FIELD SERVICE NEWS

NO : FAN-031

DATE : April 10, 1973

IMPROVEMENT OF PARKING CONTROL CABLE ASSY

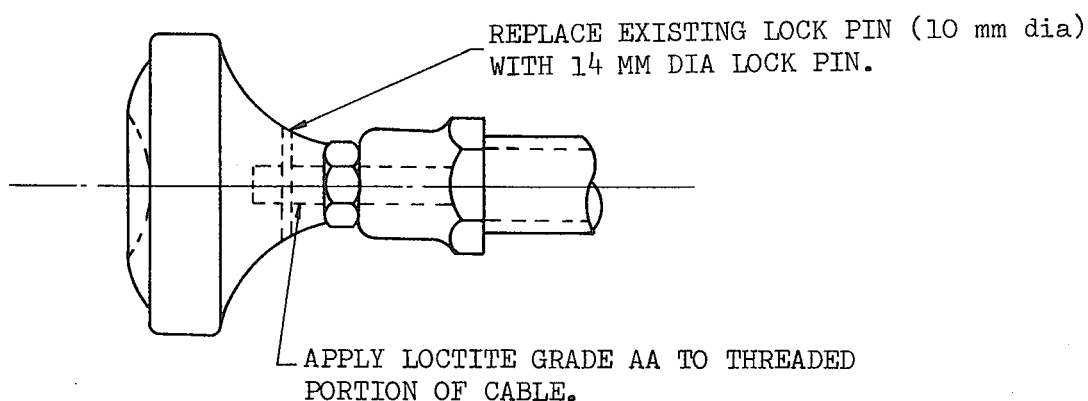
There have been a few instances reported whereby the pilot failed to operate the parking control cable assy since failure of the knob lock pin occurred due to overtightening and resulted in idle rotation of the knob. The following improvements have been made to preclude failure of the lock pin. Model FA-200 Aircraft, S/N 202 and subsequent and spare parts will have this modification accomplished prior to delivery.

1. The diameter of the lock pin has been increased to 1.4 mm from 1.0 mm.
2. Loctite grade AA has been applied to the threaded portion of the cable.

These improvements have increased locking strength greatly (approximately three times), thus eliminating possible failure of the lock pin which can be attributed to overtightening. It is, therefore, recommended that the cable assy be repaired in accordance with the following procedures, if failure of the lock pin occurs.

1. Drill out the existing pin with 1.2 mm dia drill.
2. Remove the cable from the knob. Apply loctite Grade AA to the threaded portion as shown in the accompanying figure, and reinstall the cable into the knob.
3. Drill through the knob and cable with 1.4 mm dia drill.
4. Cut 1.4 mm dia music wire (JIS G 3522 SWPA or equivalent) to a proper length (approximately 15 mm) in order to make a lock pin.
5. Insert the lock pin into the hole, and stake around the ends of the pin.
